Support Bulletin-SB-25-10043
Date-3.25.2025
Title: QuickDraw MY 25 Changes
Product Line: Spray Tender
Model: QuickDraw 3000
Level: Public
Author(s): Andy Boyle
Revision Letter: A

The following changes have been made on the MY25 QuickDraw Max Cabinets

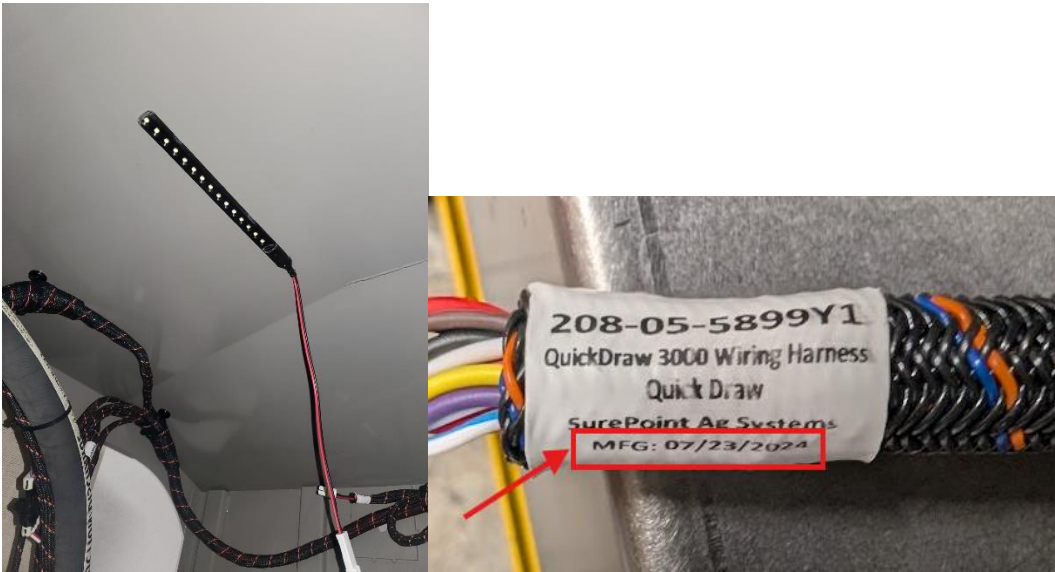
3. New controller Mounting bar / plate with Raven texture and single pim nut in on each side.

- a. 1 x 475-2339Y1-BK QuickDraw Controller Mount Bar
- b. 1 x 475-2338Y2-RV Quickdraw Controller Mount Plate
- c. 2 x 757-57715K29 Controller Mounting Knobs
- d. 4 x 340-100008-32 Machine Screws
